See below for editorial comments for the proposed code language for code change proposals to be reviewed at the MVE Committee Meeting on 9/8/2023.

Log No. 21-GP3-036 Ver. 3 8/24/23

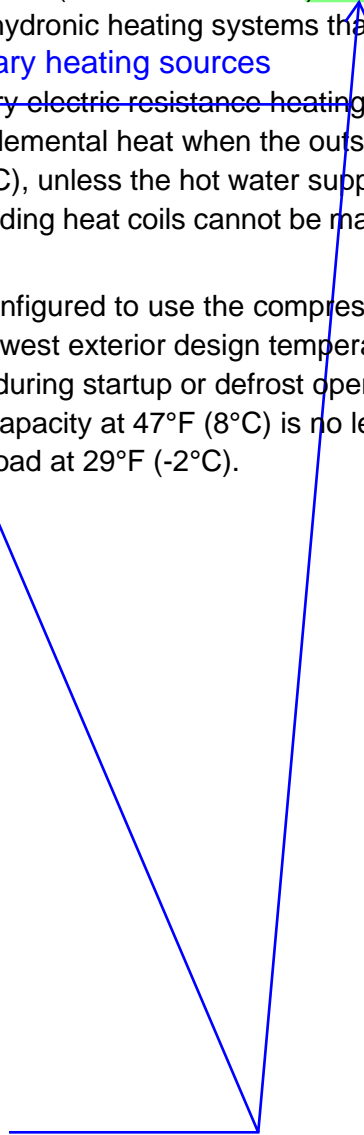
Most AWHPs do not have options for internal auxiliary heaters. This is not feasible and will greatly limit available AWHP equipment options.

Note: section above indicates its an auxiliary heater.

I only know of one manufacturer that has this option for auxiliary electric heat backup heat that is integrated packaged AWHP.

I do not know of any AWHP's that have internal fossil fuel auxiliary heaters so this would limit the option for auxiliary natural gas heat.

Recommend Item 6.1 is revising to: "auxiliary heating sources" to clarify this requirement applies to both the electric and fossil fuel auxiliary heaters.
